**Flood Control Project Maintenance
Levee Inspections****LMA District Cover Sheet****Spring 2016 Levee Inspection Results****Sacramento Maintenance Yard Maintenance Area 0004**

Levee Inspection Report By Mile - Spring 2016

Waterway	Bank	Unit Miles	Inspection Start/End	Inspector
Unit No. 01 Sacramento River	Right	3.47	04/01/2016 04/01/2016	Jai Lor

Photo 1 of 2 : UCIP_SP_2016_41557_9767.jpg

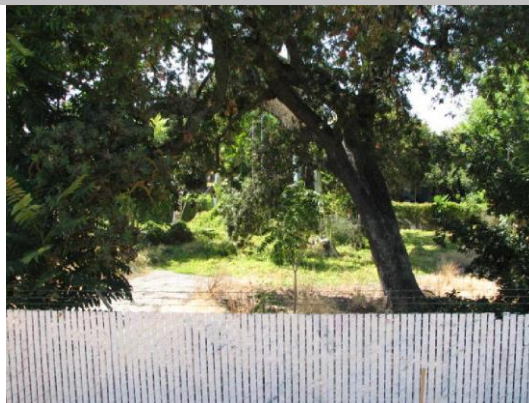
LM Start	2.93	Rating **	M	Issue No.	38
LM End	2.93	Issue Type +	En	Location *	WS
Category	Supplemental			GPS Latitude/Longitude	
				Start	End
Item	DWR UCIP Field Study			38.588688 °	38.588688 °
				-121.507910 °	-121.507910 °
DWR ID					
Comment Code					
Inspector Comment					
FS_ID:41557 DS_ID:18883 EP_NO: N/A Repair Type: Non-Urgent Crossing Status: Found UCIP Comments: Abandoned 7-inch pipe found. Needs to be abandoned properly. FIELD_STRUCT_DESC: 2 of 4. An abandoned 7-inch pipe of one 3-inch, two 7-inch and one 10-inch pipes through the levee 18.6 feet below the crown. Unable to locate. Pipes exposed and extend 10 feet from bank. O&M Manual Sac 116, August 1955, Revision Year 2011. FS Date: 9/12/2012

Land side view- Water tower area.
